MWO 189-1

# **MODIFICATION WORK ORDER**

651S-1/1A
GENERAL PURPOSE
HF RECEIVERS
(KEEP-ALIVE)

**NOVEMBER 1974**

$\label{eq:Figure 3-651S-1 Receiver With Power Pack}$  Approved For Release 2001/07/16 : CIA-RDP80900833A000100030005-7

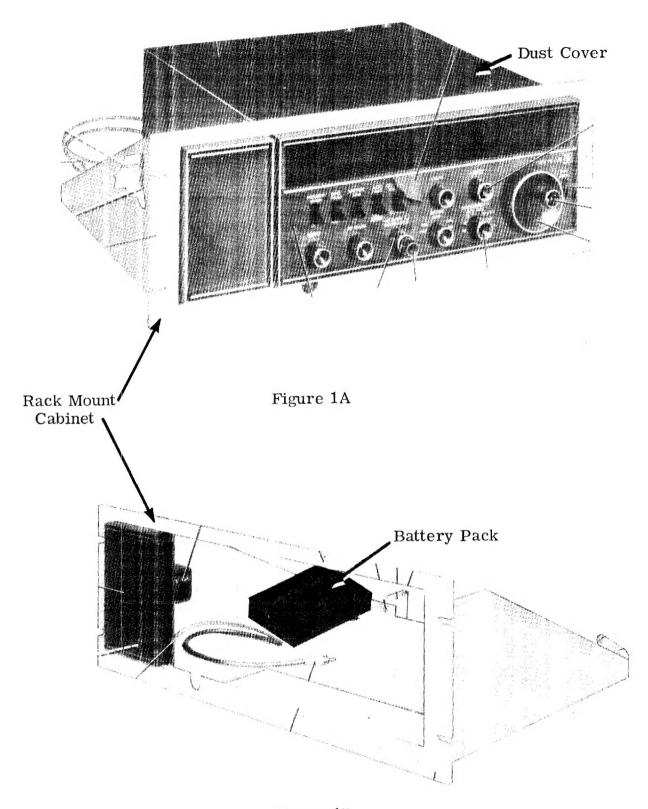
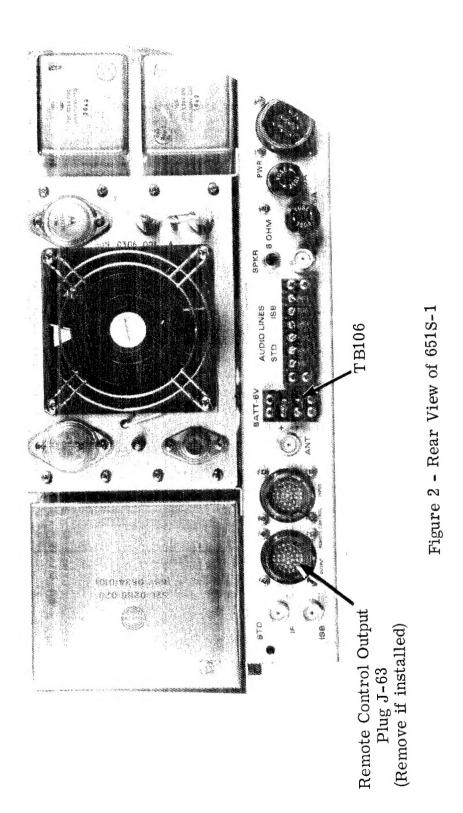
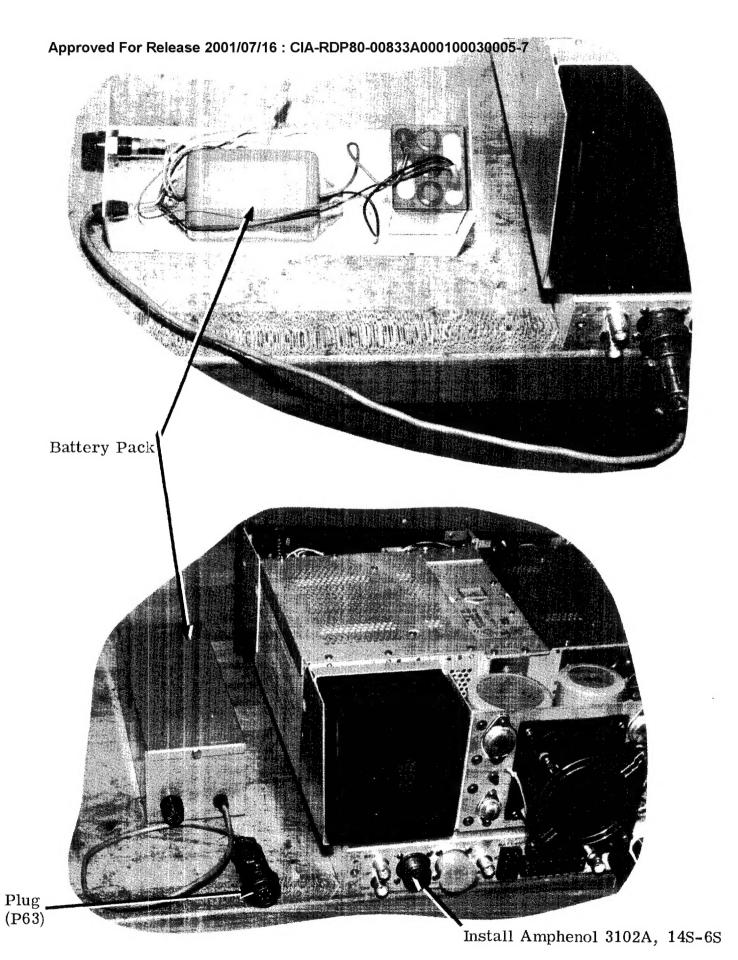
- 4.5 Install the pre-wired interface chassis mount socket (Amphenol 3102-A, 14S-6S) in the remote control output hole using the 4-40 nuts and bolts supplied. See Figure 3.

- NOTE: For purposes of standardizing, mount the socket with the key at the top. Solder the Red wire to the back of the positive terminal of TB106. Solder the black wire to the negative or ground terminal of TB106. See Fig. 3 & 8.

- 4.8 Remove the cover from battery pack and remove packing material.
- 4.9 Install the battery charger inside battery pack chassis using the holes and hardware provided. See Figure 3 for proper location.

- 4.10 Remove the paper from the tape in the bottom of the battery and press the battery down firmly inside battery pack chassis. See Figure 3 for proper location.

- 4.16 Connect the battery pack plug (P63) to the receiver. See Figure 3.
- 4.17 Pull the AC cord to check the KA circuit.

Figure 4 - 651S-1 Chassis

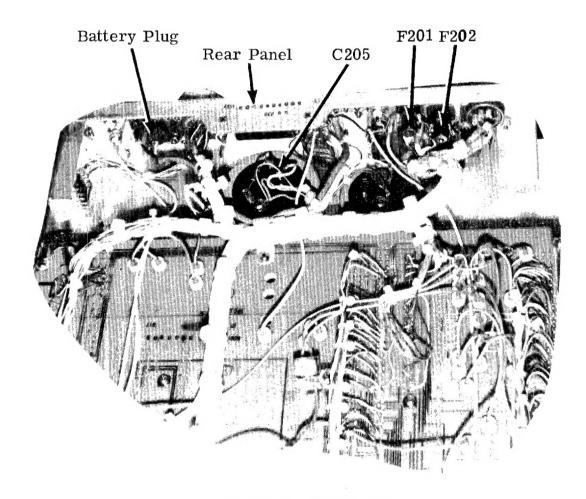
- 4.6 Solder the "White" and "Green" (110 Volt AC) wires to the rear most terminals of fuses F201 and F202. See Figure 4.
- 4.7 If the S109 Optical Tuning Switch is in an output state of "HI-LO" or "LO-HI" when the power failure occurs, with this modification, it will change the receiver frequency by as much as 400 Hz. If it is in a "HI-HI" or "LO-LO", no change will occur. To overcome this problem, the following steps must be performed.

Figure 5 - Rear View of Front Panel Assembly

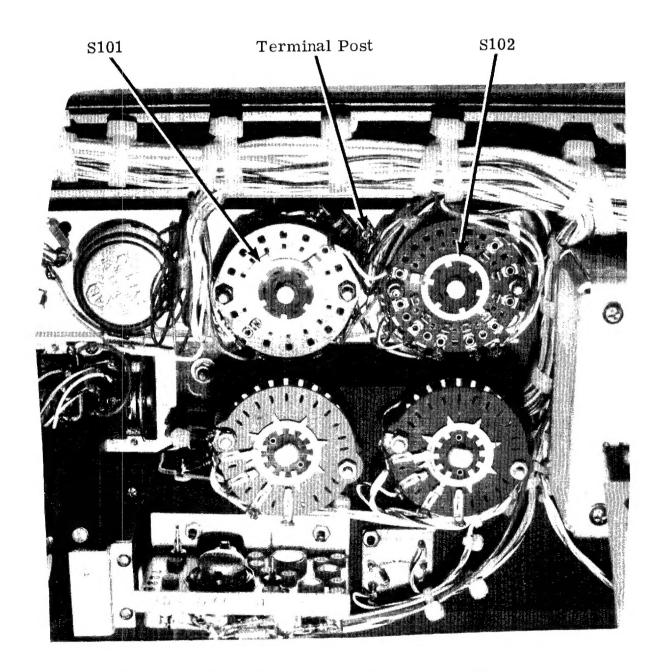
- 4.7.1 With front panel assembly removed and laying flat, locate the terminal post between the mode switch (S101) and bandwidth switch (S102) and disconnect the red wire from this post. See Figure 5.

Figure 8

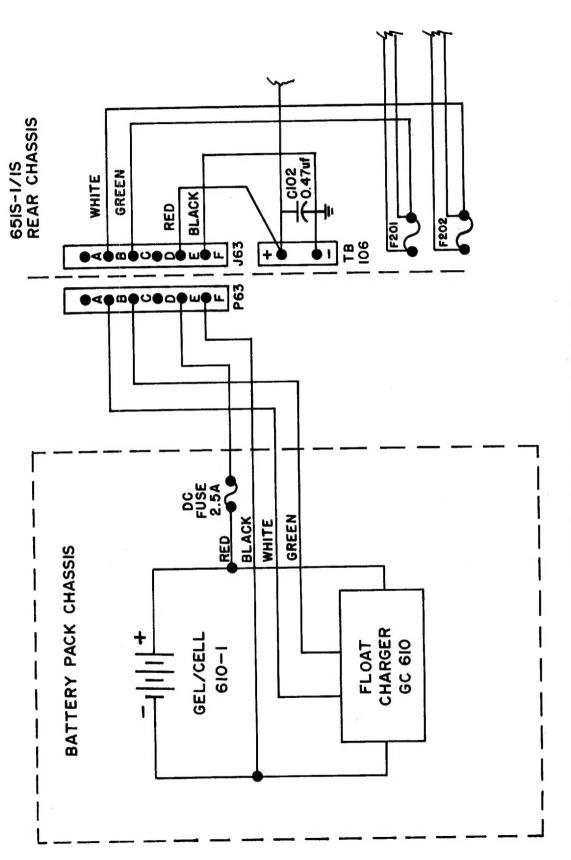
- 4.11 Make proper wiring connections to install battery charger and battery. See Figure 8 for wiring diagram.
- 4.12 Replace battery pack cover.
- 4.13 Re-assemble the front panel assembly and dust cover of the receiver.
